MATERIALS LICENSE

ISOTOPE PRODUCTS LABORATORIES  
1800 North Keystone Street  
Burbank, CA 91504

License No. 04-16778-01E  
Docket No. 030-19192  
Amendment No. 05

In accordance with letter dated May 9, 1996, License No. 04-16778-01E is amended in its entirety to read as follows:

P/N: A3916-X ASSEMBLY. Cs-137 DISK SOURCE

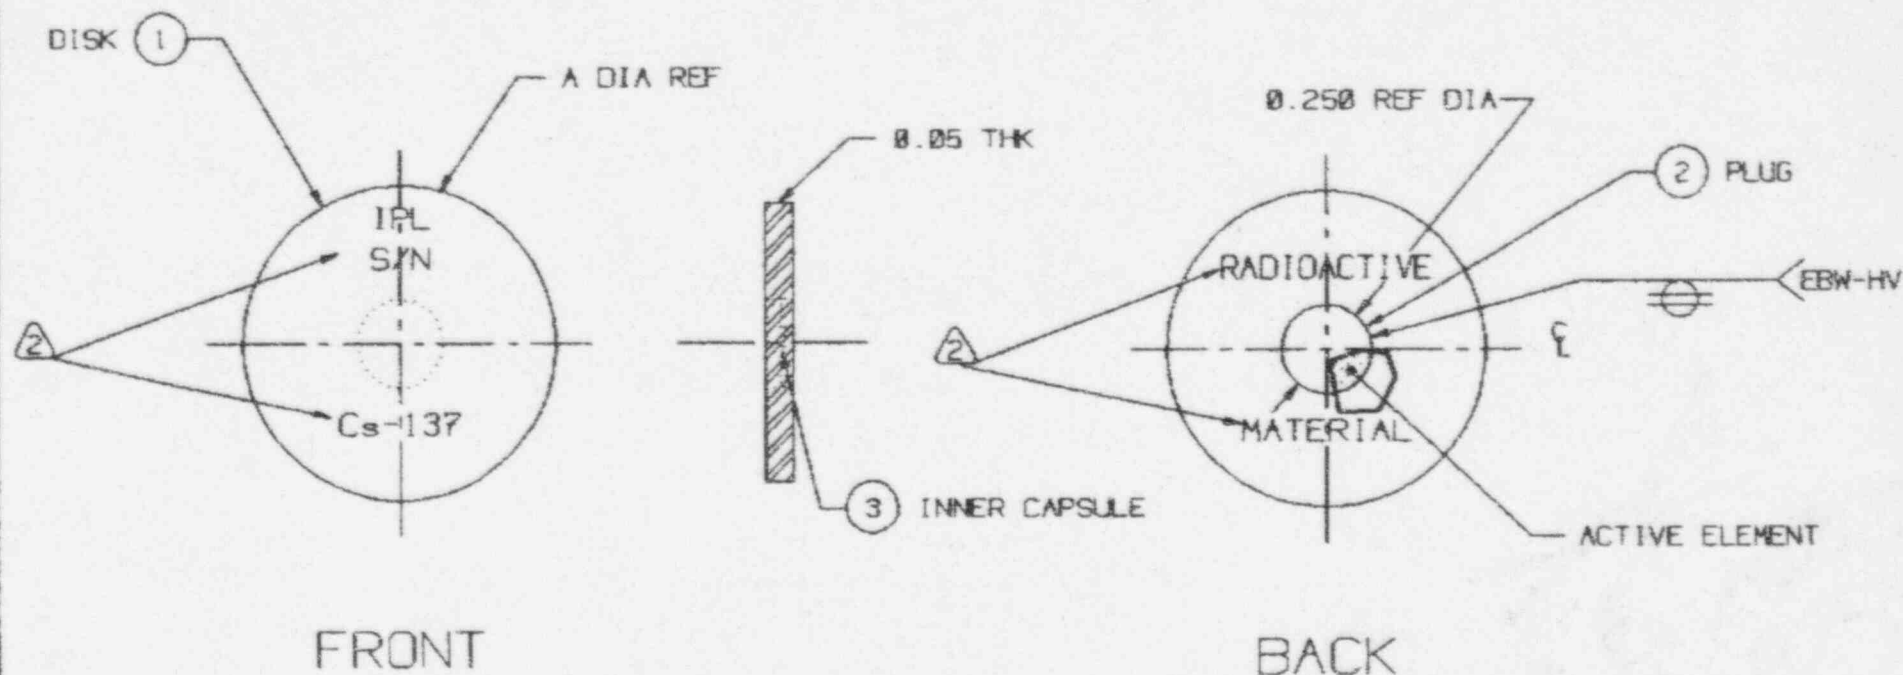
Please include the latest design of our model 3916 in Isotope Products Laboratories' pending amendment to Exempt Quantity Distribution License Number 04-16778-01E. This revision adds the 0.750" diameter size to the 3916 capsule per customer request. This rugged capsule is of welded construction and provides double encapsulation of the radioactive material within it. On the following sheet, please find a copy of the drawing for our model 3910 capsule to which an additional size (0.750" diameter) has been added.

X	A
1	0.394
2	0.895
3	0.750
